Response to Final CPE Presentation of Flamingo Ditch Feasibility Study October 28, 2025

The Flamingo Ditch Steering Committee reviewed CPE's final presentation and have identified the following questions and concerns that hopefully will be addressed during CPE's presentation or addressed by City Engineers before City Council.

Figure 1: Flamingo Ditch Tidal Interface (sand berm). Courtesy: Lueanne Wood, photo taken 10/24/2025

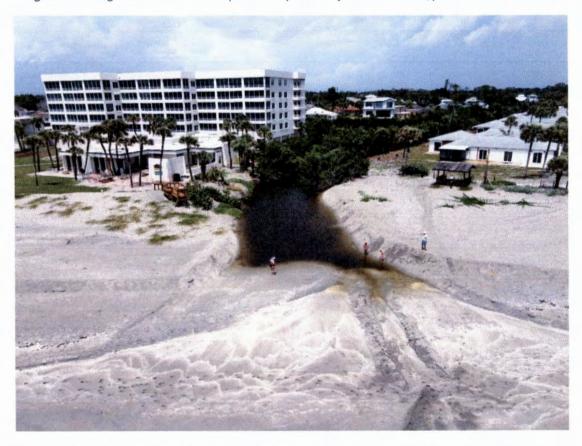
As I attempted to point out by reviewing historical engineering reports in previous City Council meetings and workshops, these historical reports identify a <u>very important gap</u> that must not be overlooked – the tidal interface from the Flamingo Ditch to the Gulf. A significant challenge is controlling sand blockages at this tidal interface. <u>It is imperative</u> that City pursue a permanent solution in partnership with the US Army Corp of Engineers!

Figure 1: Vegetation blockages at "neck" of Flamingo Ditch. Photo facing east, just south of Island Shores

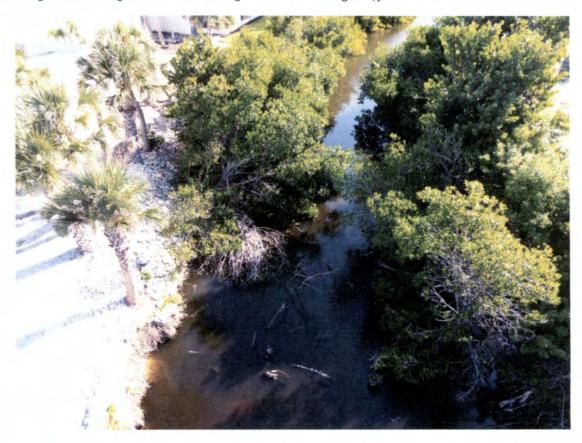
Several members of our association have voiced concerns about the lack of routine maintenance of the open swales, reinforced concrete drainage pipes, and the presence of various blockages within the Flamingo Ditch. I have a few photographs that illustrate some of these issues, showing areas in need of attention.

Residents have reached out to the City on multiple occasions requesting the clearing of these blockages, the maintenance of open swales that have significant sediment buildup, and the retrenching of swales to correct their profiles—work that has not been done in years. In addition, the closed concrete drainage pipes have accumulated several inches of sediment, which also need to be addressed to restore the full capacity of the drainage system.

Figure 14: Unhealthy east end of Flamingo Ditch behind 380 Flamingo Drive. Photo facing east.

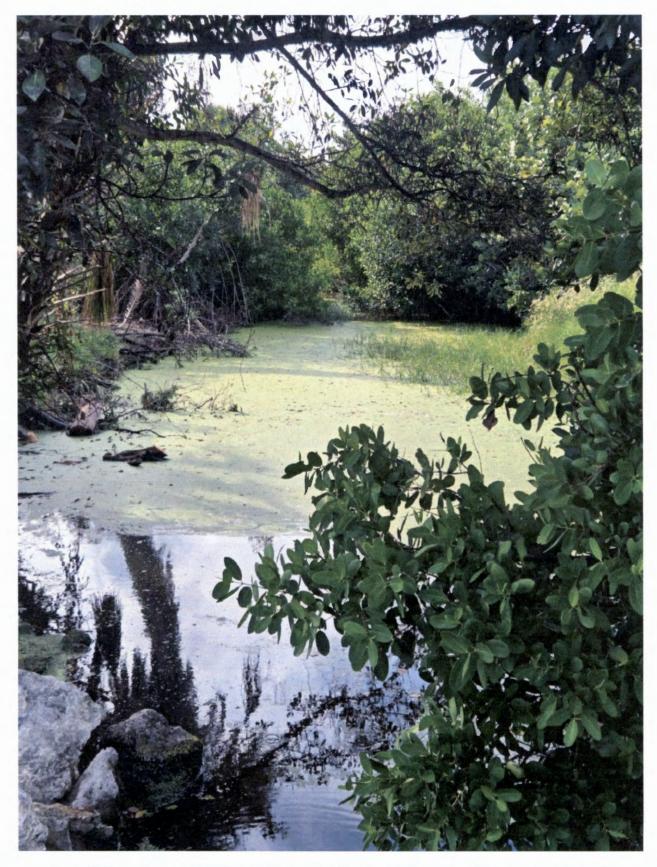
While we acknowledge the progress made, we still have several questions and concerns, and we hope the presentation today will help address many of them. In particular, we continue to have concerns about the overall health and maintenance of the entire Outfall No. 5 stormwater drainage system, not just the Flamingo Ditch.
